Access Compliance Report

Public Rights-of-Way

(Curb Ramps)

Intersection ID: 21025	Main Street: CEDAR_RUN_WY	Cross Street: SANDY_PORTER_RD	Location: N
ADA ID: 74F018B20752	Ramp Type: Perp	Initial Pass/Fail: Fail	Overall Compliance: No
Severity Score: 33.75			
Codes/Mitigation Info/Possible Solution		Field Measurements/Component Compliance

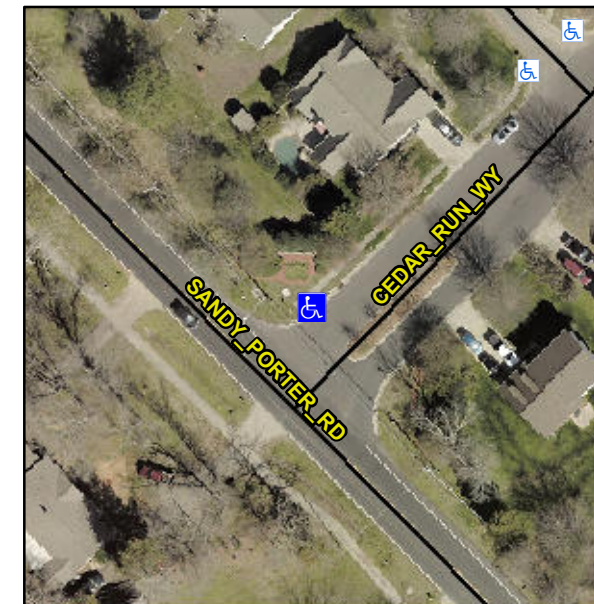
R304.5.1, R304.2.2, R304.5.3

Compliance	Description	Data	Compliance	Description	Data
N/A	Ramp Length (in)	47.0	No	Ramp Slope (%)	9.5
No	Ramp Width (in)	44.0	No	Ramp XSlope (%)	5.6
N/A	Flare Type LT	N/A	N/A	Flare Type RT	N/A
N/A	Flare Slope LT (%)	N/A	N/A	Flare Slope RT (%)	N/A
N/A	Flare Traversable LT?	N/A	N/A	Flare Traversable RT?	N/A
N/A	Landing Length (in)	N/A	N/A	DWS Provided?	N/A
N/A	Landing Width (in)	N/A	N/A	DWS Contrast?	N/A
N/A	Landing Slope (%)	N/A	N/A	DWS Length (in)	N/A
N/A	Landing X Slope (%)	N/A	N/A	DWS Full Width?	N/A
N/A	Landing Curb? (Y/N)	N/A	N/A	DWS Offset (in)	N/A
N/A	Shared Landing?	N/A			
N/A	Gutter Ponding?	N/A	N/A	Gutter Slope (%)	N/A
N/A	Gutter Lip Ht (in)	N/A	N/A	Gutter X Slope (%)	N/A
N/A	Painted X Walk1?	No	N/A	Painted X Walk2?	N/A
	X Walk 1 Direction	To SE		X Walk 2 Direction	N/A
N/A	X Walk 1 Width (in)	N/A	N/A	X Walk 2 Width (in)	N/A
	X Walk 1 Slope (%)	0.6		X Walk 2 Slope (%)	N/A
	X Walk 1 X Slope (%)	3.4		X Walk 2 X Slope (%)	N/A

Remove & Replace Entire Ramp.
